Letter of Intent – Land Use Application for Plan Commission and Common Council Initial/Final Approval Request PROJECT:
Peloton Residences
1004 & 1032 S. Park Street Madison, WI

AYA Project # 59830 02/18/2019

Based on feedback our team received from the Urban Design Commission at the January 2, 2019 Urban Design Commission meeting, we have made the following updates and modifications to the plans. Overall, the feedback we received was a resounding request to return the 5th story facades on both Park St. and Fish Hatchery back to the visual aesthetic that was approved in fall of 2017, with relation to the windows and roof line. Additional feedback received was in regard to access to the rooftop patio space, and the need to allow access to both a potential future commercial tenant and residents of the property. Below, you'll find a list of the modifications and updates we've made to address that feedback.

Urban Design Commission Major Alteration Submittal

RENDERED AND SHADOWED ELEVATIONS - Fish Hatch

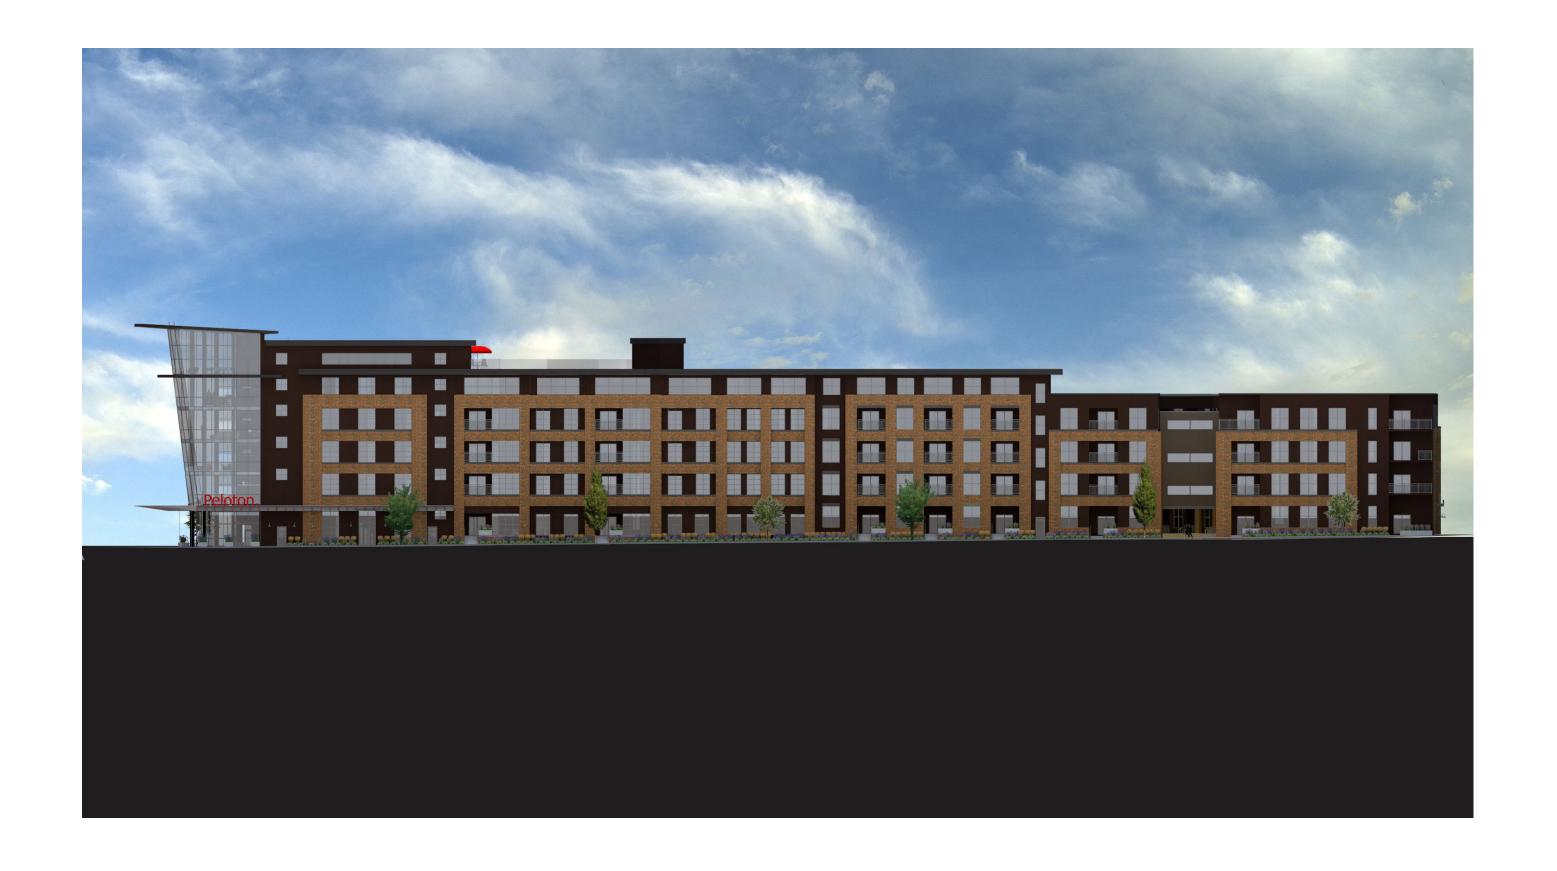
- 1. Park St. 5th floor facade glass on Park St. has been increased and mullion size has been decreased. Window sections once again align with the balconies and windows below them.

- 2. Fish Hatchery The 5th floor roof line has been extended to once again carry through towards the prow of the building. Glass has been added to the commercial space facade. 5th floor facade glass has been increased and mullion size has been decreased. Window sections once again align with the balconies and windows below them.

PROPOSED PERSPECTIVE RENDERINGS - Prow

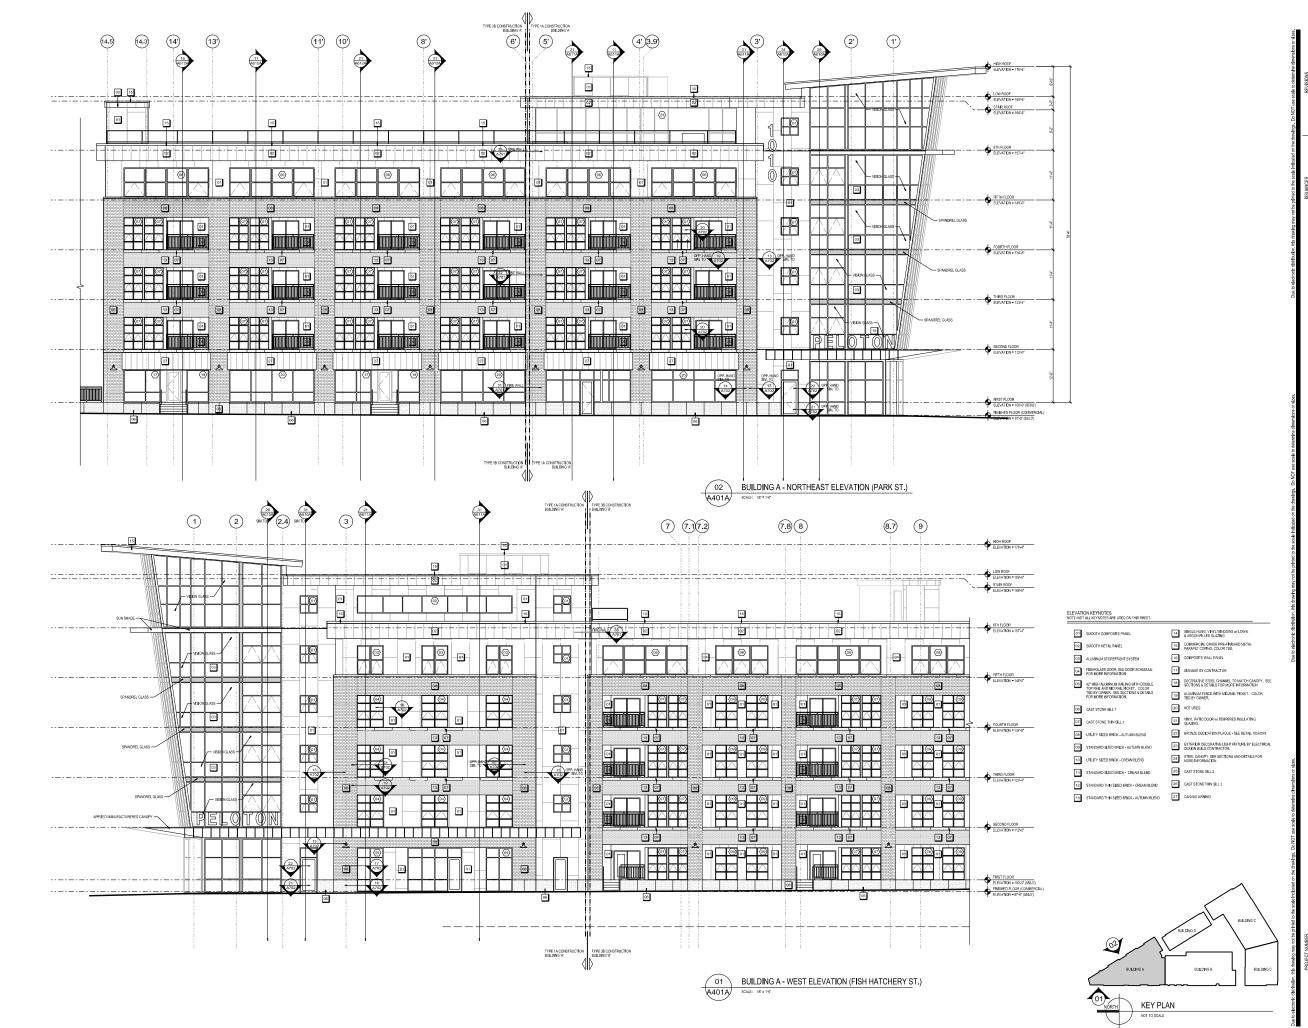
- 3. Rooftop Patio We've created a separate secured entrance, that is A.D.A. accessible, off of the elevators that will allow building residents access to the rooftop patio regardless of a commercial tenant in the prow space. The railing for the rooftop patio has been switched from metal to glass, and the umbrellas/tables/chairs have been added back in to indicate that this space is indeed a rooftop patio.

- 4. Rooftop Patio Emergency Exit Stair The height and size of the secondary emergency exit stair, that penetrates the roof line, has been decreased and is shown at it's minimum size.

- 5. Prow Rendering During our February 13th presentation to the Urban Design Commission, there was some question and confusion as to what the material treatment between each floor section on the exterior facade would be. The updated rendering shows spandrel glass as the material covering the concrete slab at floors 2-5 on the buildings facade. In effort to further make the initial concept renderings accurate to date, we have updated the prow renderings to match the Construction Documents.
